Access Compliance Report

Public Rights-of-Way

Intersection ID: 16128	Main Street: HEMPSTEAD_PL	Cross Street: LOCKLEY_DR	Location:	SW
ADA ID: 366DCDD2227D	Ramp Type: PerpDiag	Initial Pass/Fail: Fail	Overall Compliance: No	Severity Score: 25
Codes/Mitigation Info/Possible Solution		Field Measurements/Component Compliance

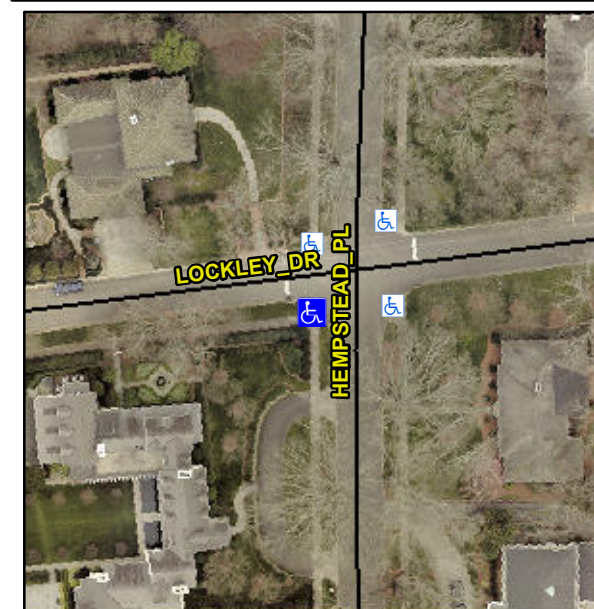
Not Found, R304.5.3

Compliance	Description	Data	Compliance	Description	Data
N/A	Ramp Length (in)	57.0	Yes	Ramp Slope (%)	6.5
Yes	Ramp Width (in)	48.0	No	Ramp XSlope (%)	10.4
N/A	Flare Type LT	N/A	N/A	Flare Type RT	N/A
N/A	Flare Slope LT (%)	N/A	N/A	Flare Slope RT (%)	N/A
N/A	Flare Traversable LT?	N/A	N/A	Flare Traversable RT?	N/A
N/A	Landing Length (in)	N/A	N/A	DWS Provided?	N/A
N/A	Landing Width (in)	N/A	N/A	DWS Contrast?	N/A
N/A	Landing Slope (%)	N/A	N/A	DWS Length (in)	N/A
N/A	Landing X Slope (%)	N/A	N/A	DWS Full Width?	N/A
N/A	Landing Curb? (Y/N)	N/A	N/A	DWS Offset (in)	N/A
N/A	Shared Landing?	N/A			
N/A	Gutter Ponding?	N/A	N/A	Gutter Slope (%)	N/A
N/A	Gutter Lip Ht (in)	N/A	N/A	Gutter X Slope (%)	N/A
N/A	Painted X Walk1?	No	N/A	Painted X Walk2?	No
	X Walk 1 Direction	To E		X Walk 2 Direction	To N
N/A	X Walk 1 Width (in)	N/A	N/A	X Walk 2 Width (in)	N/A
	X Walk 1 Slope (%)	1.4		X Walk 2 Slope (%)	4.0
	X Walk 1 X Slope (%)	4.8		X Walk 2 X Slope (%)	1.9

Remove & Replace Curb Ramp With Two New Directional Ramps or Equivalent.
